### **Analysis of the portions of the FAA initiative to Address Noise Concerns of Santa Cruz/Santa Clara/San Mateo/San Francisco Counties, Compiled at the Requests of Representatives Farr, Eshoo and Speier relative to aircraft landing at San Francisco International Airport (SFO). Phase One actions.**

**Prepared by Williams Aviation Consultants at the request of the Towns of Portola Valley, Los Altos Hills and Woodside.**

**July 20, 2016**

Figure E.1: Comparison of how the BSR and the SERFR were flown

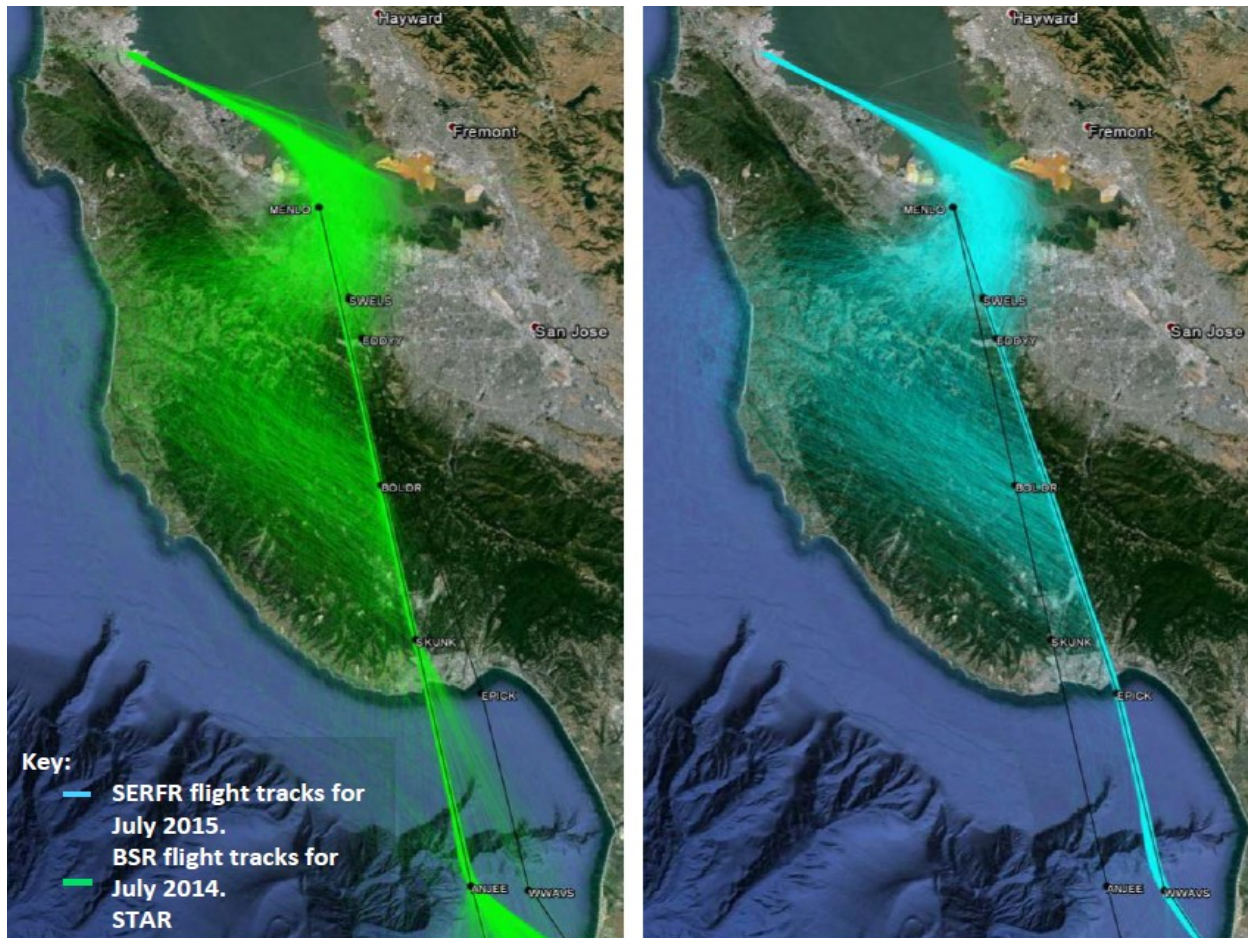
The second proposal involved developing PBN procedures which would disperse flights over a wider area. This includes parallel routes. The FAA rejected this proposal because dispersion of flight is already occurring. The FAA states: “in order to accommodate the volume of traffic merging into the Bay Area airports without increasing ground delays, traffic is typically vectored off their respective procedure”. Many peninsula towns and cities have identified the aircraft being vectored as the primary source of the increased noise they are experiencing. While the FAA appears to admit this activity is occurring, they refuse to discuss or analyze any possible solution. While the vectoring of aircraft may cause some dispersion, if aircraft are routinely and repeatedly placed over the same communities, it can hardly be called equitable. **Figure E 1** in the appendices, shown below, depicts the tracks of those aircraft receiving vectors. Every aircraft is vectored west of the published route. If this was truly equal distribution, some aircraft would be vectored east of the published procedure.

The idea that 17% of oceanic arrivals cross Woodside VORTAC below 8000 feet is unacceptable to the residents impacted by these aircraft. The ATC facility has in place a local requirement that 8000 feet is the minimum altitude for oceanic arrivals over Woodside. The fact that some airlines prefer to use an unpublished procedure that is in conflict with local criteria is not justification for the FAA to allow it to occur. The statement that “for safety reasons it is not feasible to raise these arrivals to 8000 feet MSL” is false. A review of this issue is certainly feasible. In addition, the Town of Woodside is impacted by many of those aircraft being vectored off the SERFR STAR (see **Figure E. 1**).
